**Constructability, Structural Engineering
Feasibility and Cost Study for the
Gardiner Expressway/
Lakeshore Boulevard Options**

**Constructability, Structural Engineering
Feasibility and Cost Study for the
Gardiner Expressway/Lake Shore
Boulevard Options**

Toronto Waterfront Revitalization Corporation
207 Queens Quay West, Suite 822
Toronto, Ontario
M5J 1A7

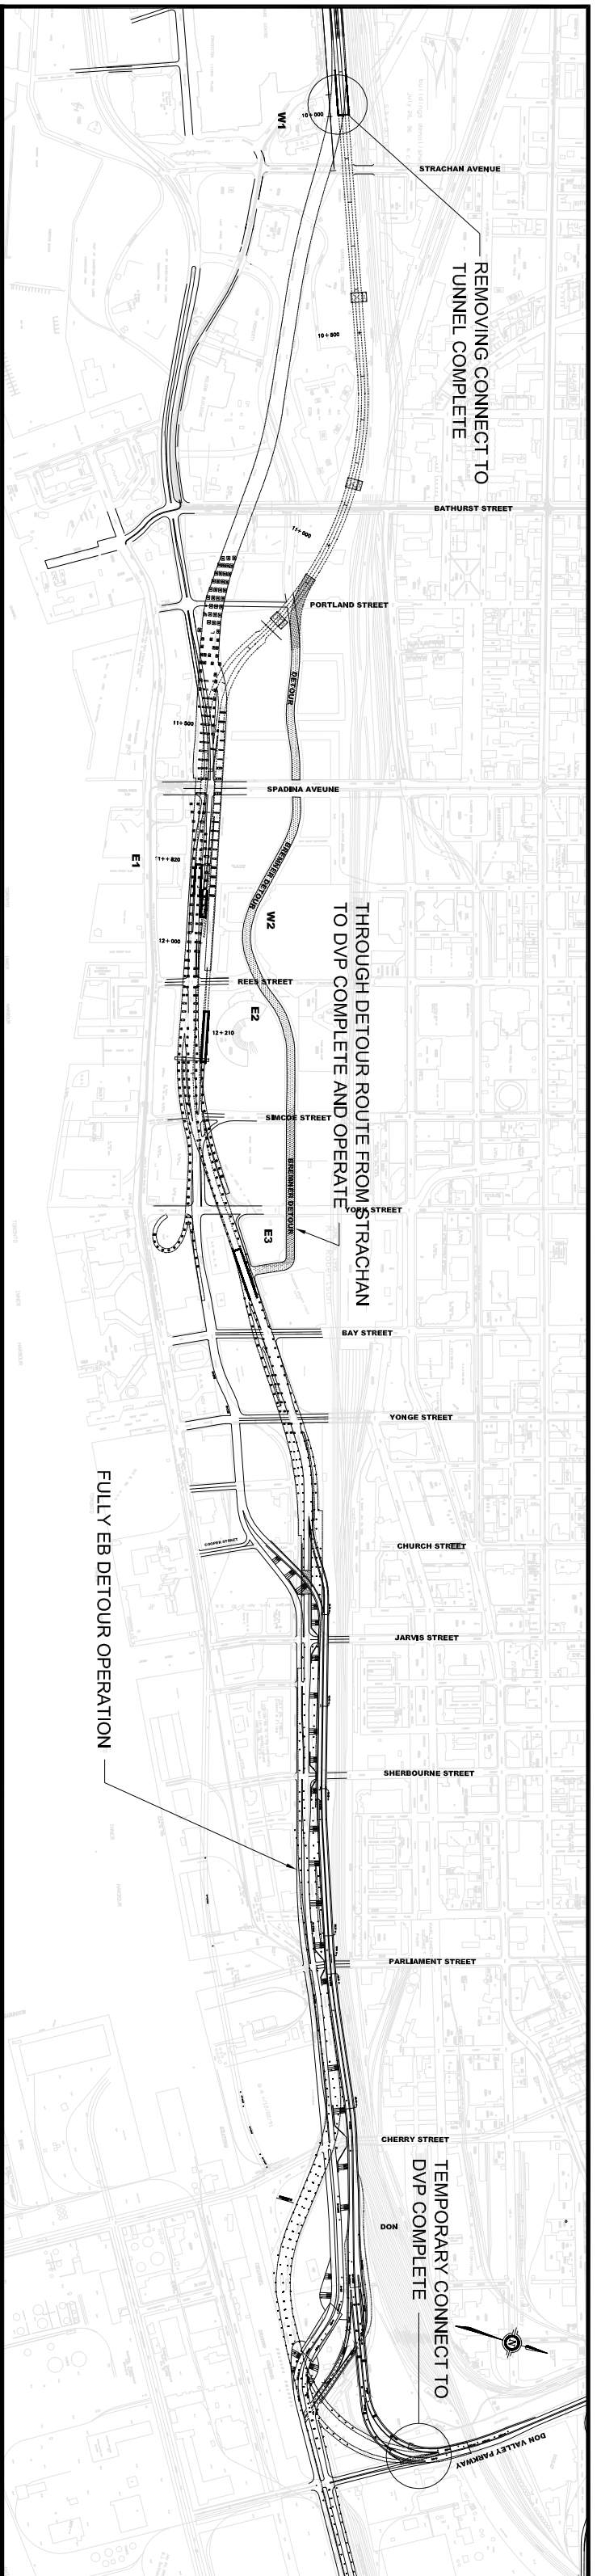
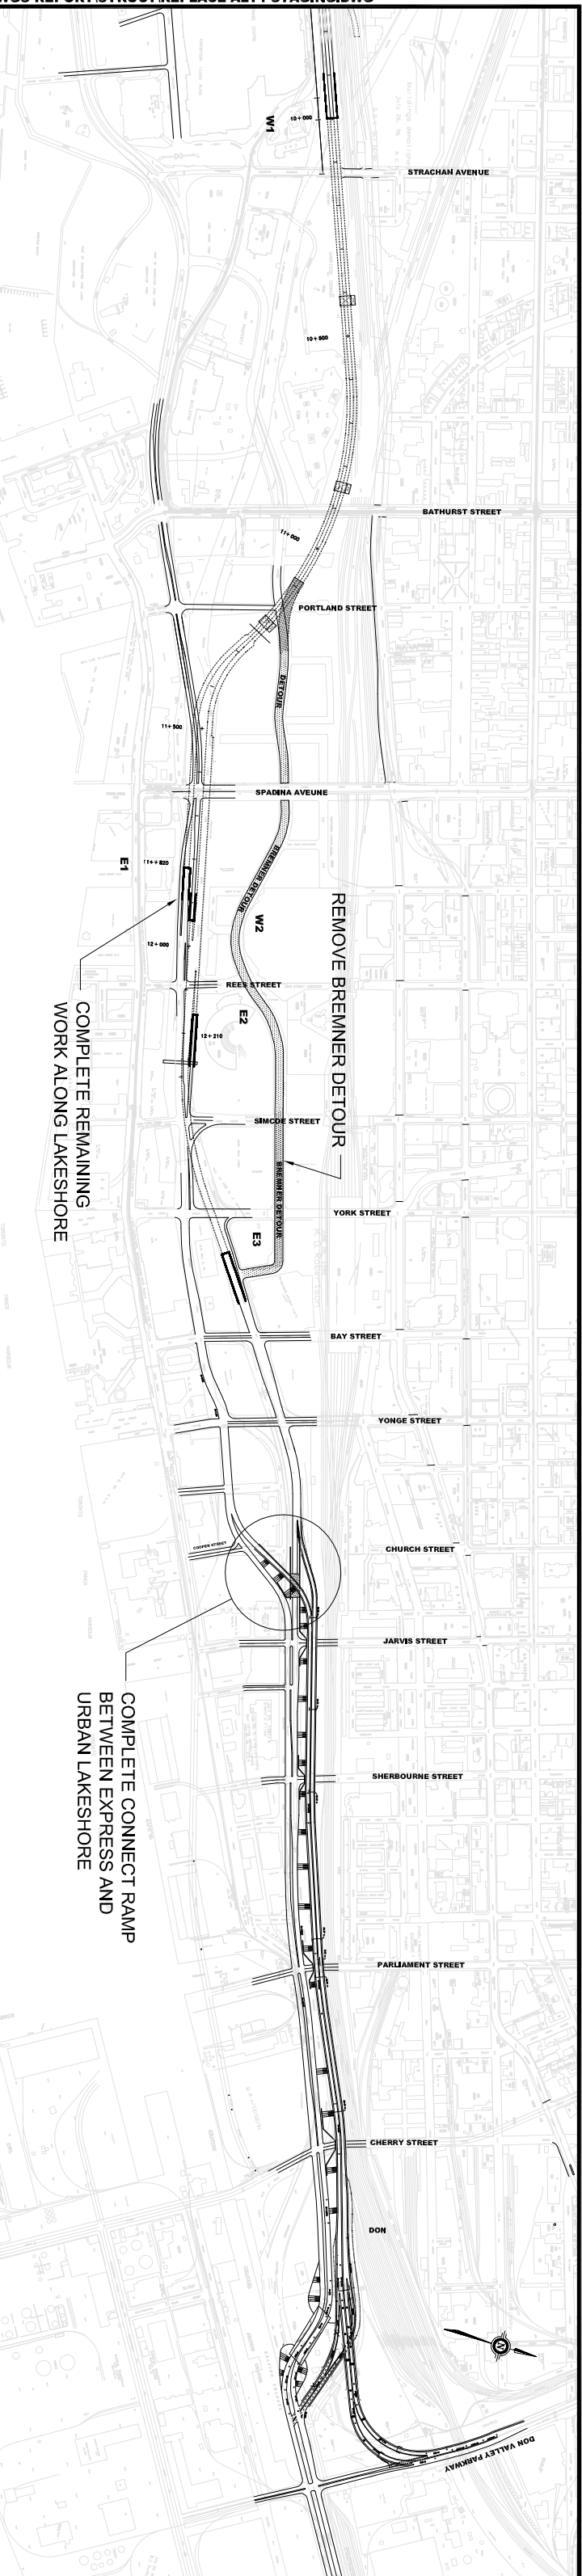
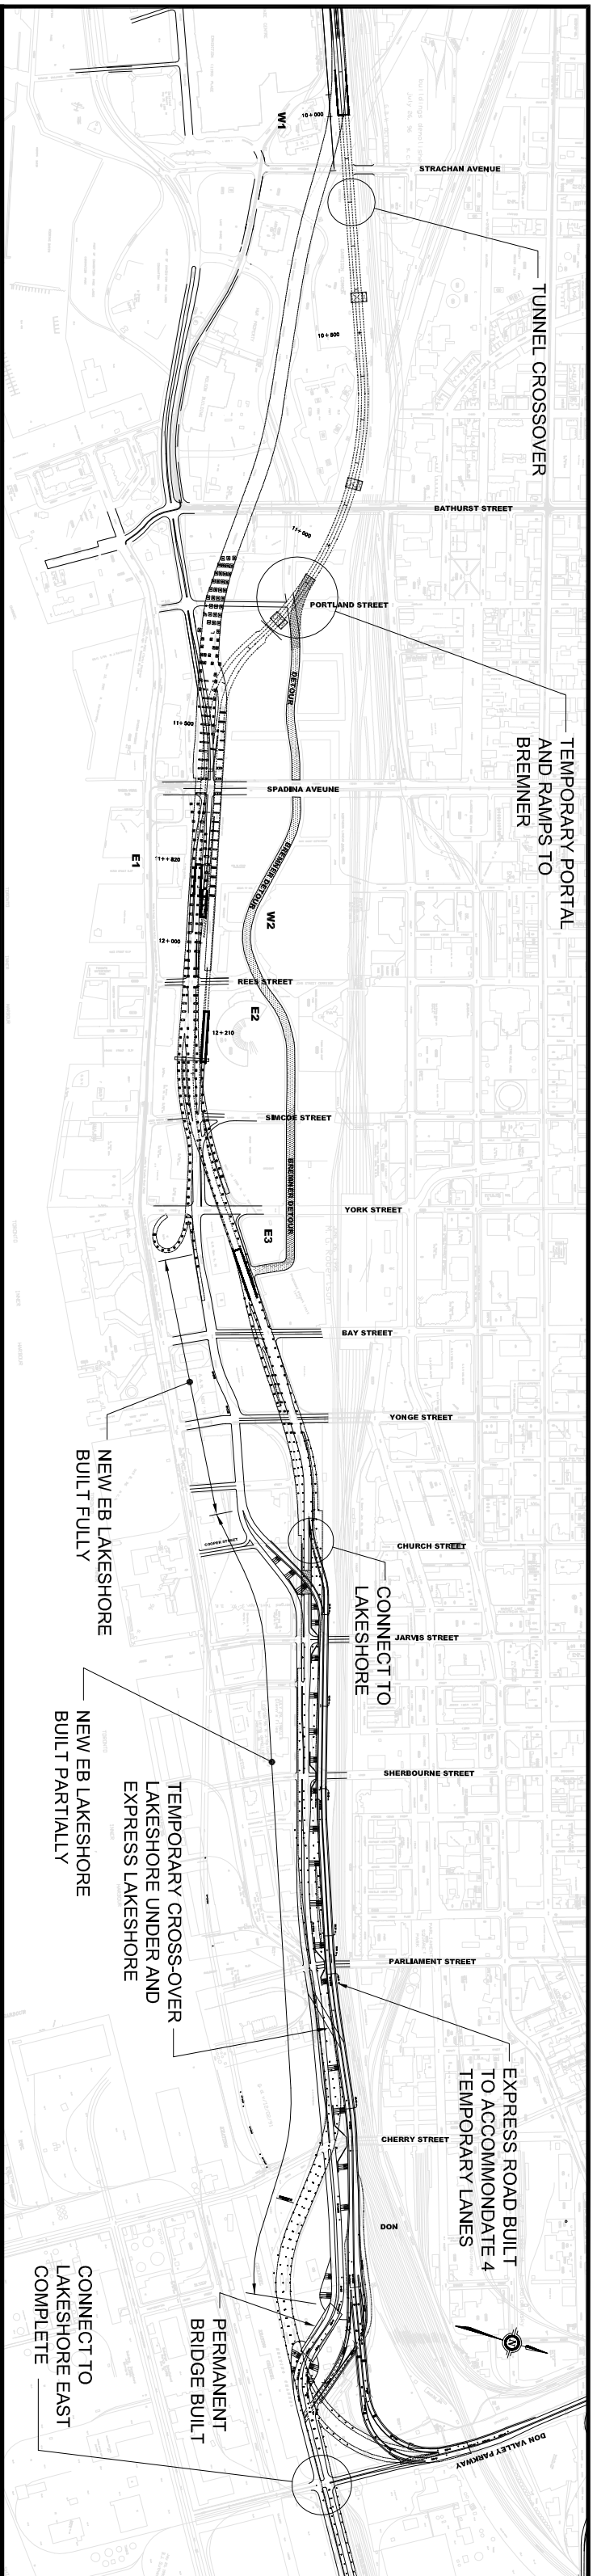
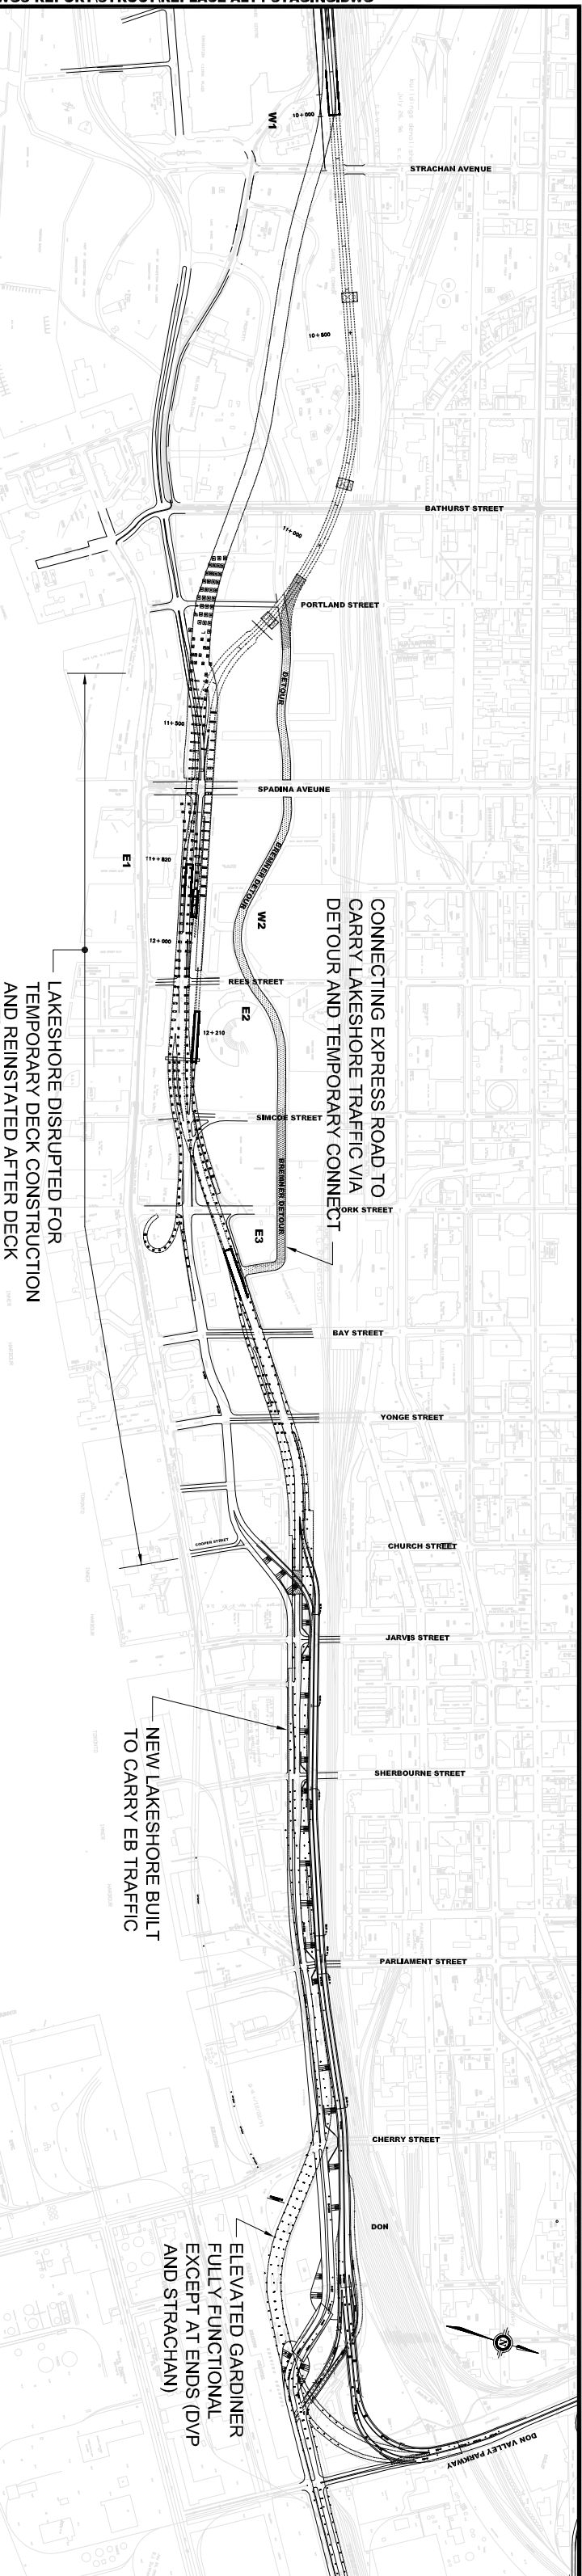
There are apparently a number of similar but slightly different alternatives where traffic disruption will be minimized during the construction of the Replace Option facilities. The following is one feasible solution, comprising a total of 4 stages. Only the concept of the operation is illustrated. More details including lane provision and actual transition and connections, will be developed further in future design stages.

GARDINER EXPRESSWAY STUDY FOR TWRC - "REPLACE" OPTION
TYPICAL CROSS-SECTION
GARDINER TEMPORARY SUPPORT AND WEST TUNNEL CONSTRUCTION

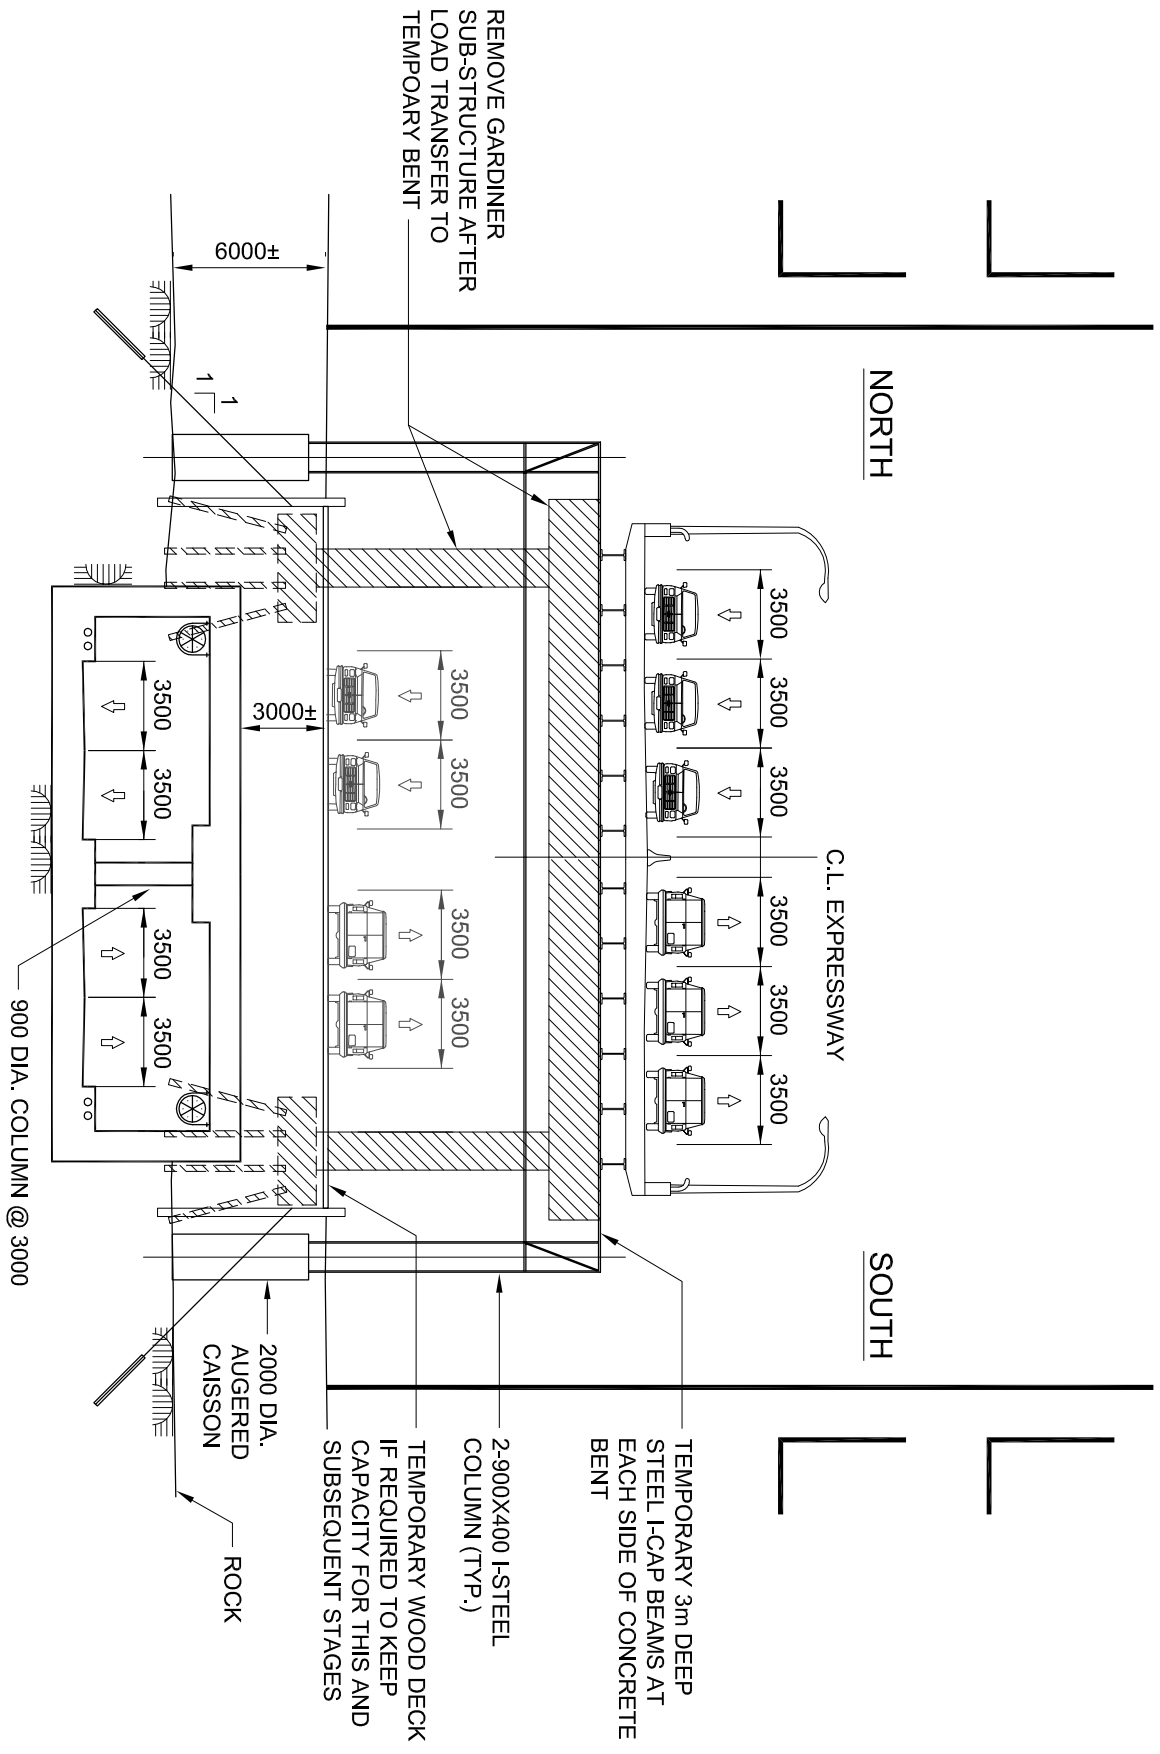
- a. Localized conflict with the foundations of the existing Gardiner should be carefully reviewed. It is noted that the situation is particularly significant between Spadina Avenue and Simcoe Street. This problem has been discussed in detail above, and is illustrated in Appendix 2.

**Sketches Related to Constructability Issues
For the Retain Option**

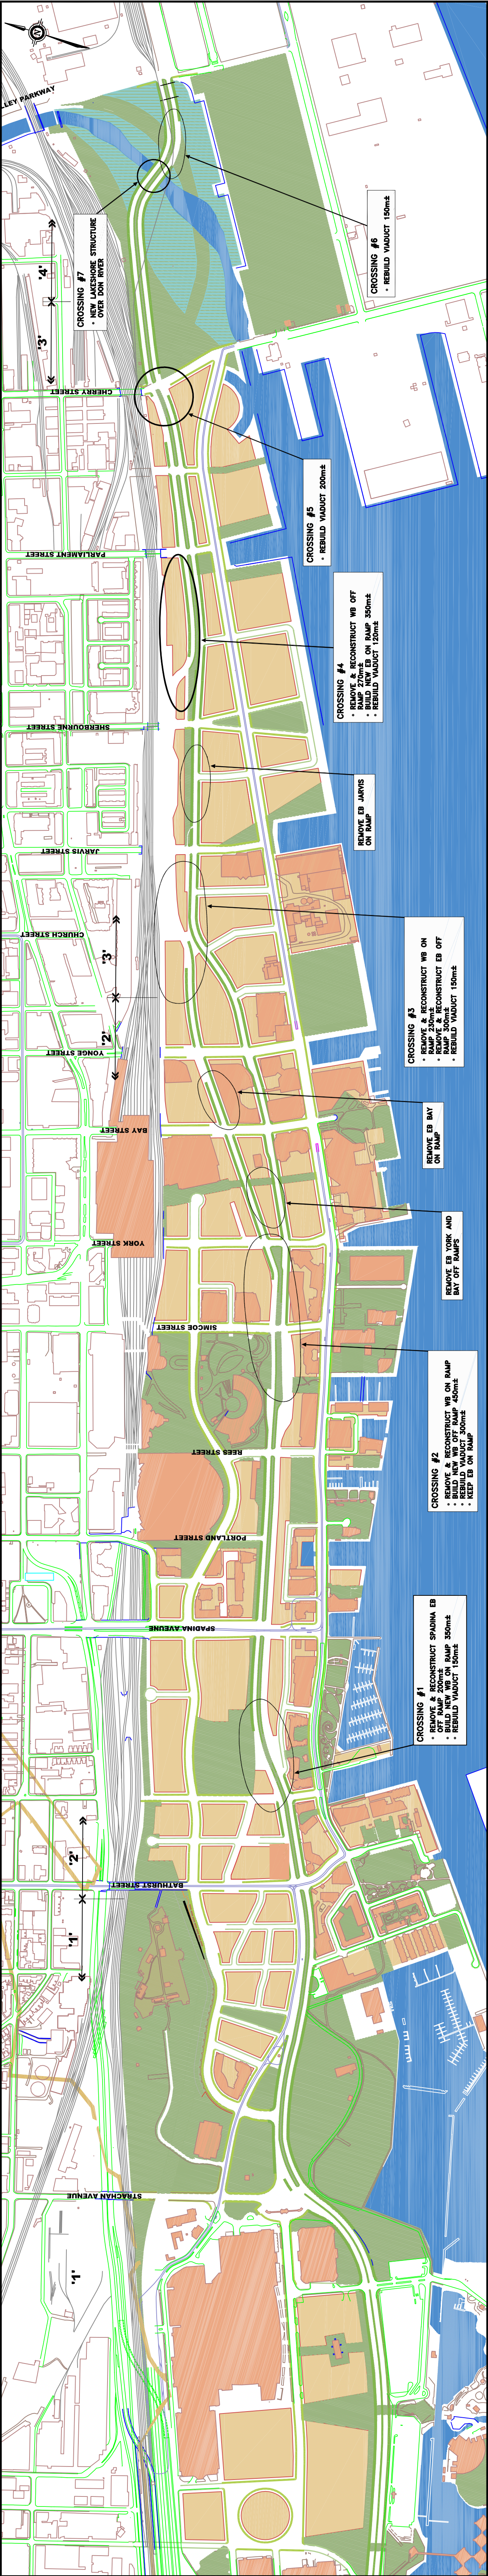
2. There will be problems in threading connecting roads in between the existing columns of the Expressway, as identified in the proposed plan at 6 locations shown on the drawing enclosed in Appendix 3. These crossings occur where Lake Shore Blvd is moved out from under the Expressway, where a low level “ramp-type” road would be required to connect N-S streets with the new Lake Shore, and where the new Lake Shore weaves across below the elevated Gardiner. Given the existing column arrangement, and the oblique angles these intersections would make with each other, the supporting structure and the deck of the entire section of the elevated Gardiner at these locations should be re-constructed so as to put the new piers and columns in line with the alignments of the connecting roads. Removal will include the deck, girders as well as the substructures up to approximately 1000 mm below ground level. The sections affected will be rebuilt with the substructure relocated at an appropriate location to suit the new access road alignments.
